PCI 2.3 Update Document

This document details the changes between the 2.2 and 2.3 version of the PCI specification. The 2.3 specification changes fall into the following categories:

This document is intended to be an addendum to MindShare's PCI System Architecture book, 4th edition, based on the 2.2 version of the PCI specification. The document is organized in order of occurrence of changes that are associated with the book and the 2.3 specification. The changes described in this document are incorporated into a 5th edition book available only in electronic form. This 5th edition book is in pdf format and can be purchased at http://www.mind-share.com/books/books_main.html. This electronic edition of the book also incorporates the 4th edition errata and ECNs that include:

Figure 3-5: Power, Clock, and Reset Timing

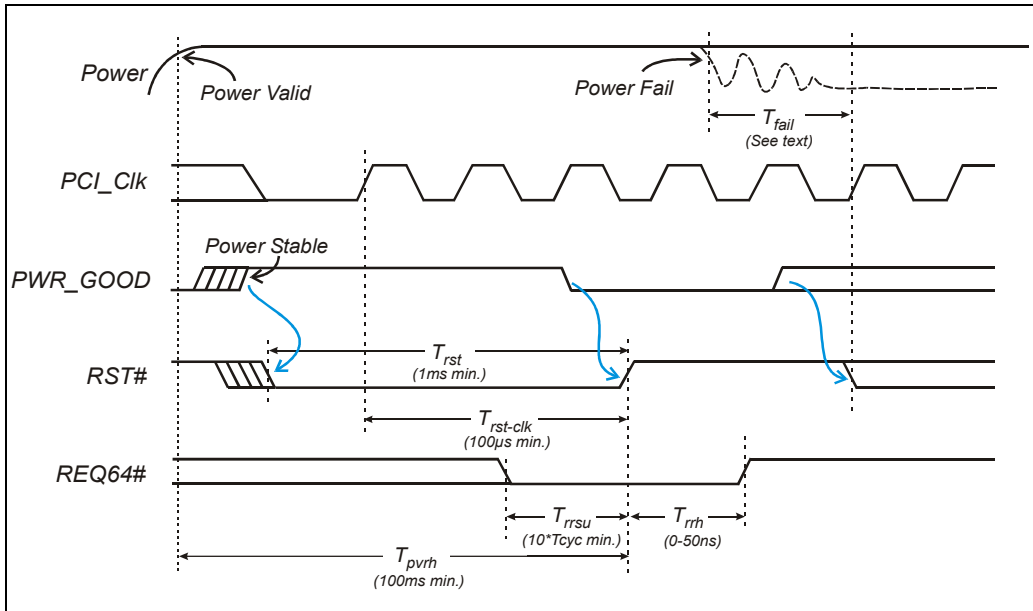
The section on RST#/REQ64# Timing on page 29 of the 4th edition has been rewritten and expanded. A timing diagram has been added to illustrate the timing relationships between power, clock, and reset. Also, the definition of Tfail has been added to the discussion and timing diagram.

The only change to this section that is brought about by the 2.3 specification is a new parameter defined as "power valid to reset high" timing (Tpvrh). The discussion of this parameter is highlighted in red below and is illustrated in figure 3-5.

- *DURING THE FIRST RESET SEQUENCE (I.E. POWER-UP), RST# MUST REMAIN ASSERTED FOR 100MS FROM POWER VALID (TPVRH). NOTE THAT IF RST# IS ASSERTED WHILE THE POWER SUPPLY VOLTAGES REMAIN WITHIN THEIR SPECIFIED LIMITS (E.G. A SOFTWARE RESET), THE MINIMUM PULSE WIDTH OF RST# IS TRST.*

Figure 4-1: PCI-Compliant Master Device Signals

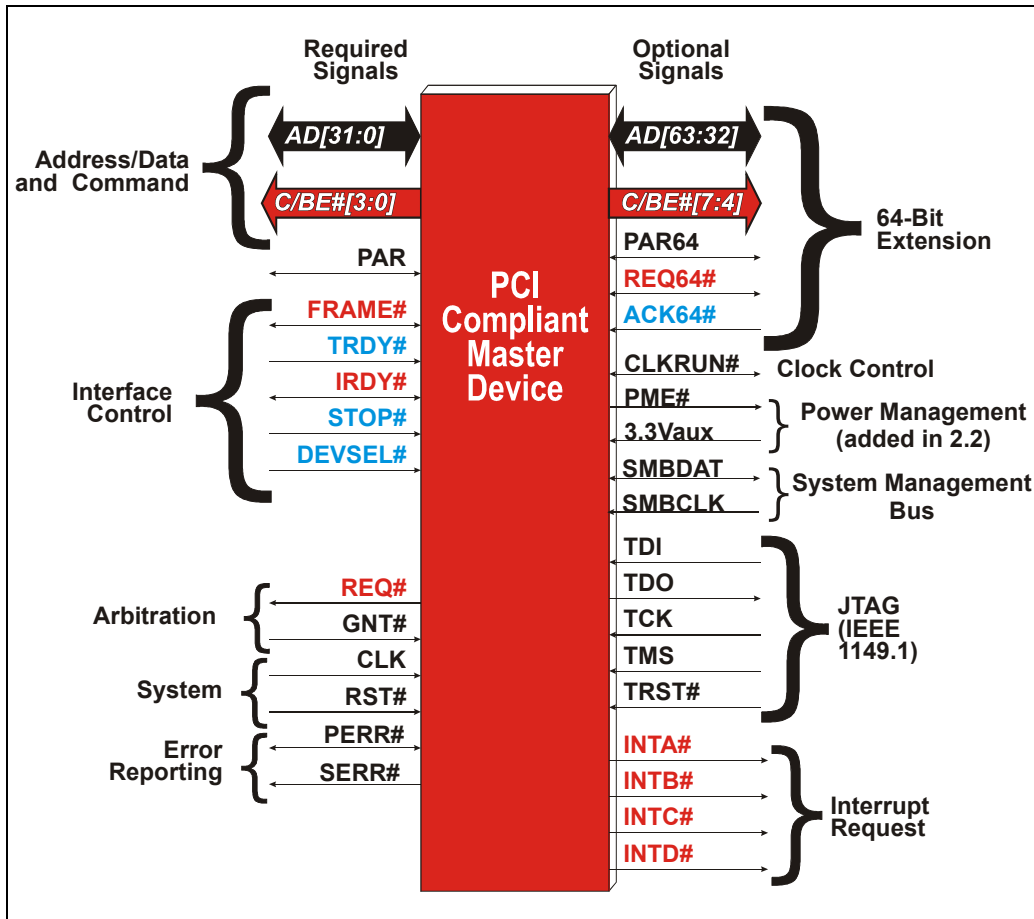
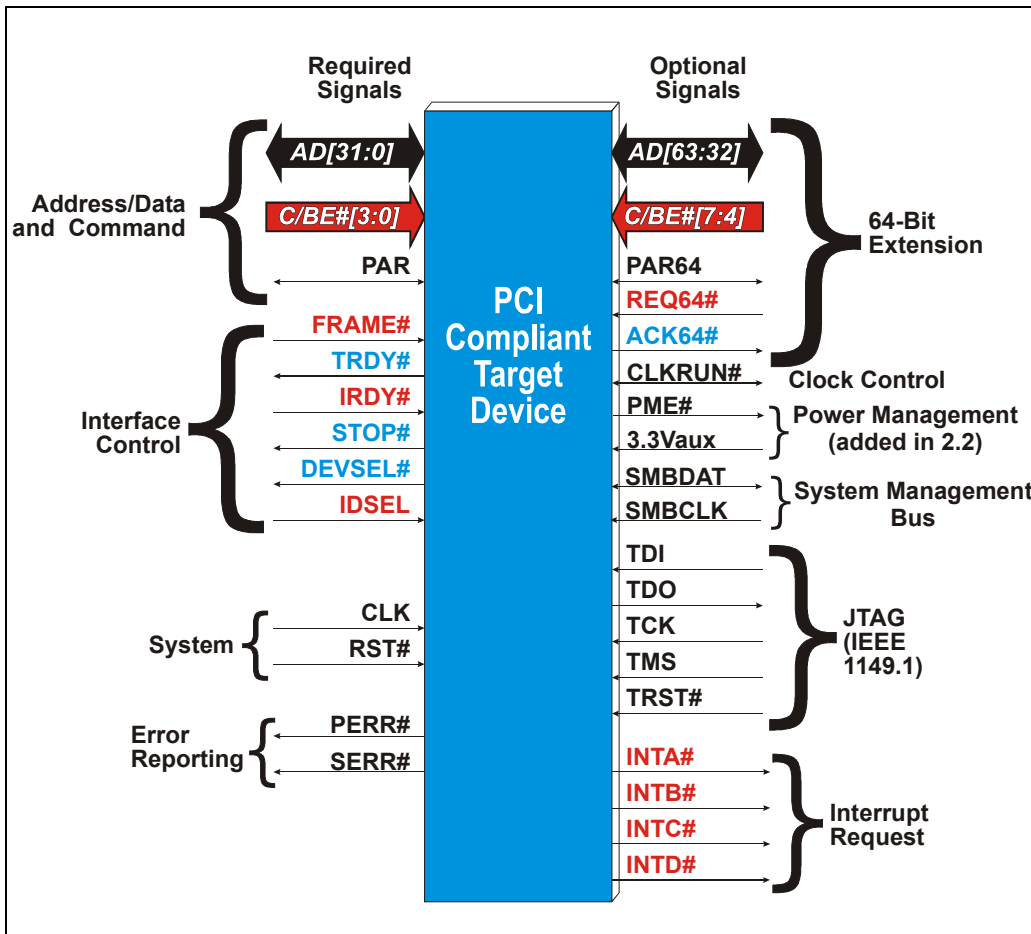
- Figures 4-1 and 4-2 now include the SM Bus interface signals.
- A new section on the SM Bus interface has also been added
- The section on Snoop Support Signals has been removed.
- Table 4-7 now includes the SM Bus signals.

Figure 11-3: Example of *IDSEL* Stepping

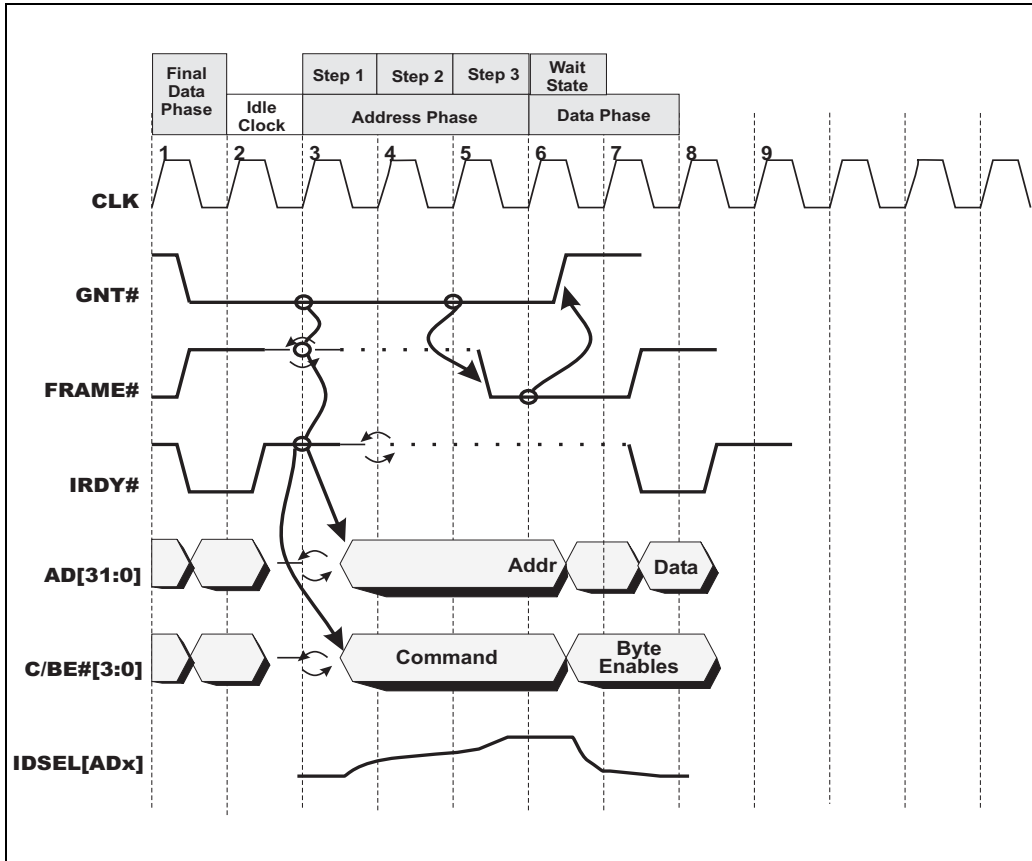
THE 2.3 SPECIFICATION HAS RENAMED ADDRESS/DATA STEPPING TO IDSEL STEPPING. THE NAME CHANGE DENOTES USE OF STEPPING ONLY FOR TYPE ZERO CONFIGURATION TRANSACTIONS. SPECIFICALLY, 2.3 PERMITS THE USE OF STEPPING ON IDSEL PINS WHEN THEY ARE DRIVEN VIA AD SIGNALS THROUGH RESISTIVELY-COUPLED CONNECTIONS.

FIGURE 11-3 ON PAGE 11 PROVIDES AN EXAMPLE OF AN INITIATOR USING STEPPING OVER A PERIOD OF THREE CLOCKS TO DRIVE THE ADDRESS ONTO THE AD BUS.

Figure 14-4: Interrupt Disable Bit Added to Configuration Command Register

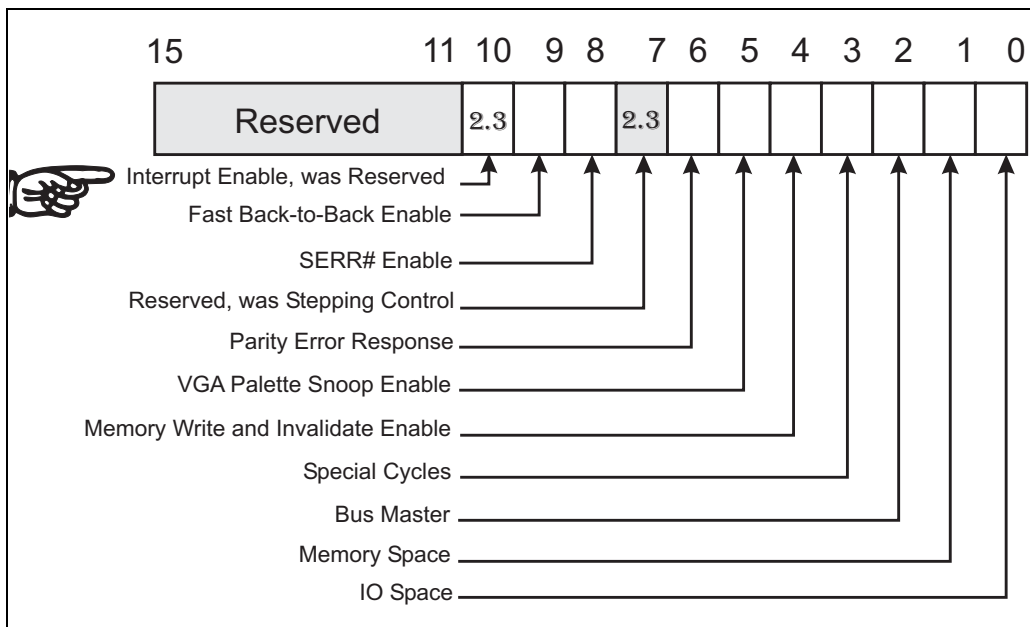
THE 2.3 SPECIFICATION ADDED AN INTERRUPT DISABLE BIT (BIT 10) TO THE CONFIGURATION COMMAND REGISTER. SEE FIGURE 14-4 ON PAGE 12. THE BIT IS CLEARED AT RESET PERMITTING GENERATION OF INTX SIGNAL GENERATION. SOFTWARE MAY SET THIS BIT THEREBY INHIBITING GENERATION OF INTERRUPTS VIA THE INTX SIGNALS. NOTE THAT THE INTERRUPT DISABLE BIT HAS NO EFFECT ON MESSAGE SIGNALLED INTERRUPTS (MSI). THESE INTERRUPTS ARE ENABLED VIA THE MSI CAPABILITY COMMAND REGISTER.

Figure 14-5: Interrupt Status Bit Added to PCI Configuration Status Register

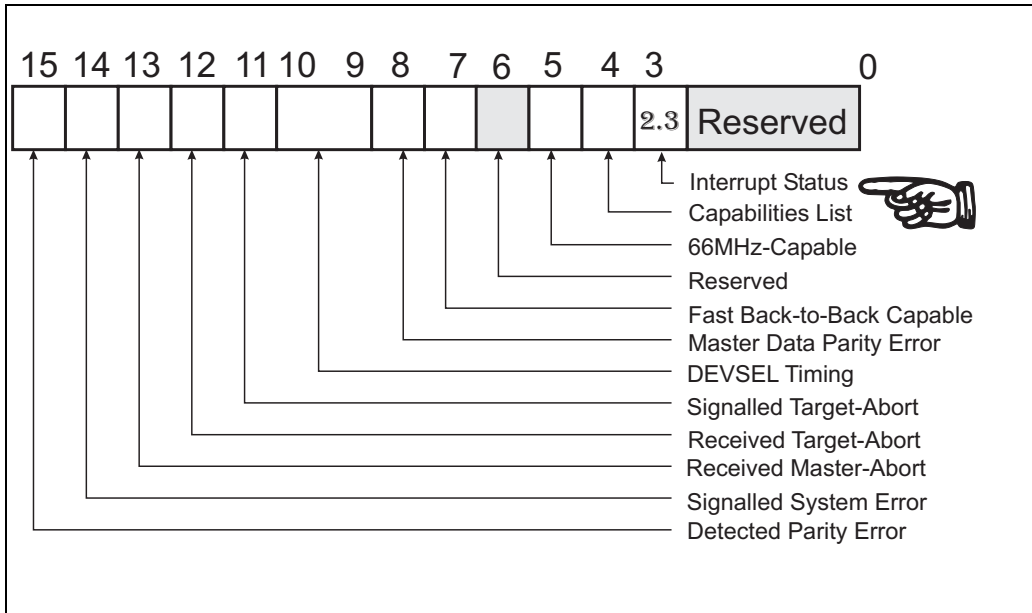
THE 2.3 SPECIFICATION ADDED AN INTERRUPT STATUS BIT TO THE CONFIGURATION STATUS REGISTER (PICTURED IN FIGURE 14-5 ON PAGE 14). A FUNCTION MUST SET THIS STATUS BIT WHEN AN INTERRUPT IS PENDING. IN ADDITION, IF THE INTERRUPT DISABLE BIT IN THE CONFIGURATION COMMAND REGISTER IS CLEARED (I.E. INTERRUPTS ENABLED), THEN THE FUNCTION'S INTx# SIGNAL IS ASSERTED, BUT ONLY AFTER THE STATUS BIT IS SET. THIS BIT IS UNAFFECTED BY THE STATE OF THE INTERRUPT DISABLE BIT, AND THIS BIT HAS NO AFFECT ON THE MSI MECHANISM.

Figure 19-3: Command Register Bit Assignment

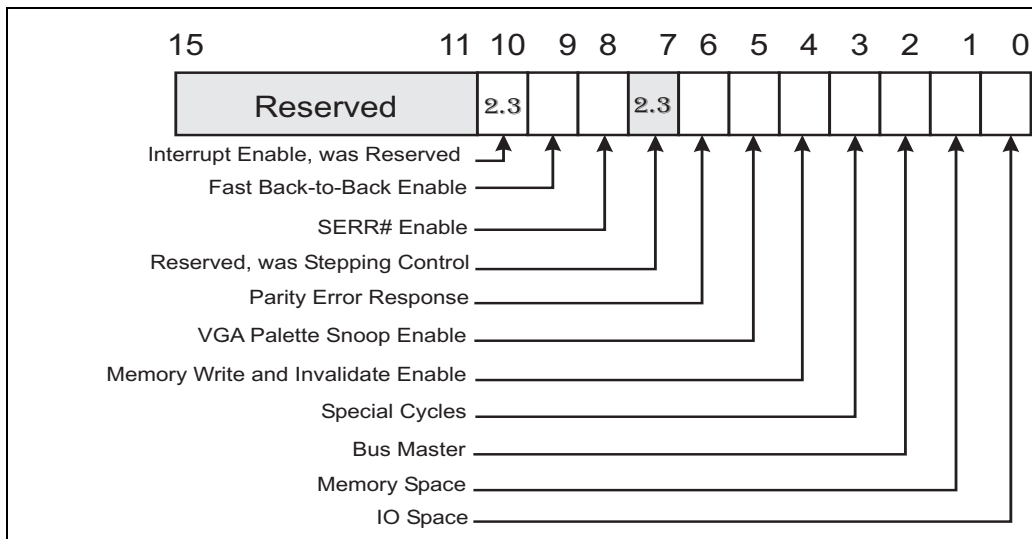
- Bit 7, previously defined as Stepping Control is now Reserved.
- Bit 10, previously Reserved is now defined as Interrupt Disable.

Table 19-21 on page 18 pictures the bits that have changed with the introduction of the PCI 2.3 specification and the register is illustrated in Figure 19-3 on page 17.

Figure 19-4: Status Register Bit Assignment

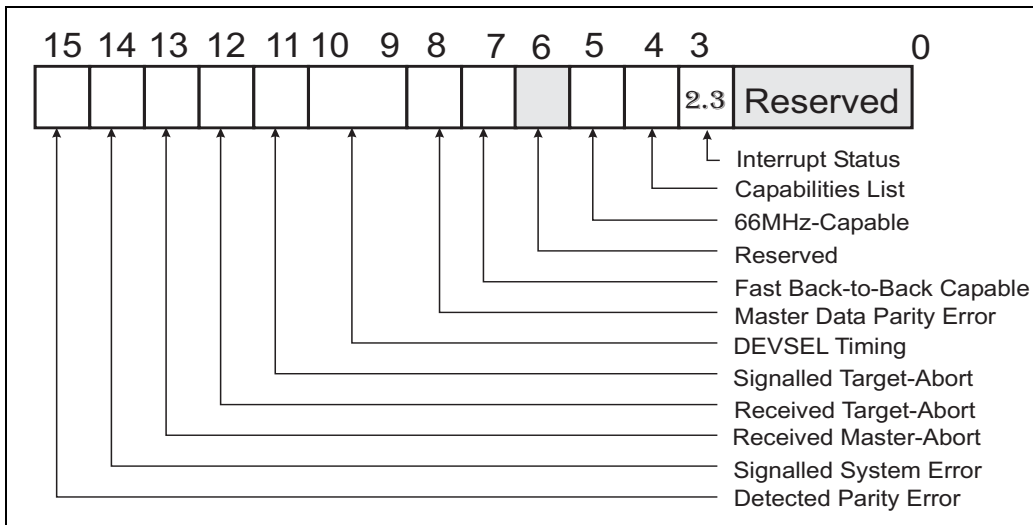
Figure 19-4 pictures the Status Register and Table 19-22 on page 19 describes the Status register bit that has been added by the PCI 2.3 spec.

Figure 21-3: 3.3V, and Universal Card (5V Only Cards Not Support by Ver. 2.3)

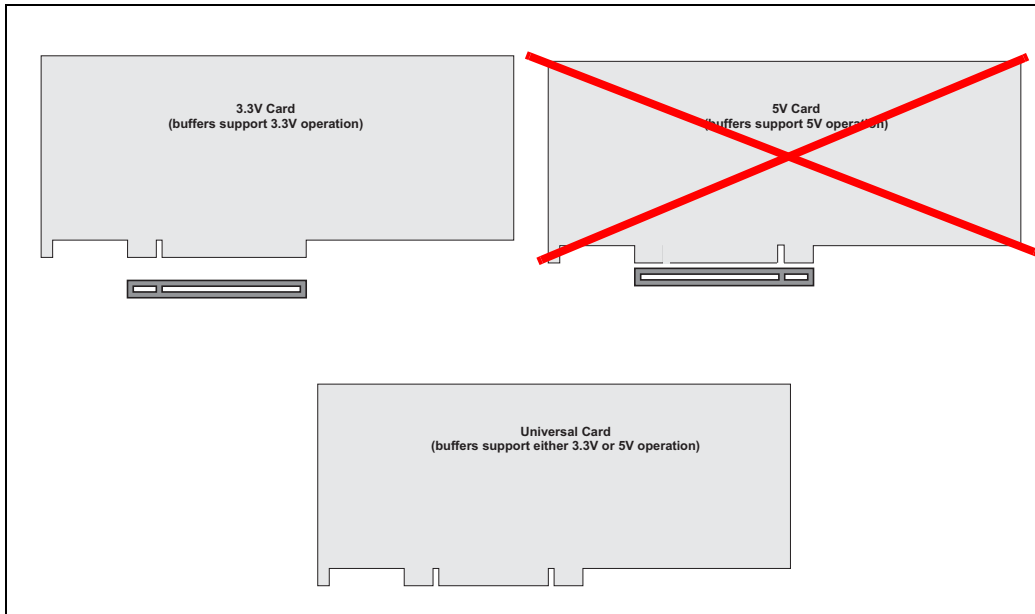
- ELIMINATION OF THE 5 VOLT ONLY CARD — TO PUSH THE MIGRATION FROM 5V-ONLY IMPLEMENTATIONS TO OR 3.3V OR UNIVERSAL CARD IMPLEMENTATIONS. NOTE THAT THIS DOES NOT AFFECT 5V CONNECTORS.
- ADDITION OF TWO NEW PINS TO SUPPORT THE SYSTEM MANAGEMENT BUS IN PCI.

Figure 21-3 on page 21 illustrates the change in support for 5V only cards that only the Universal card provides 5V connector compatibility.
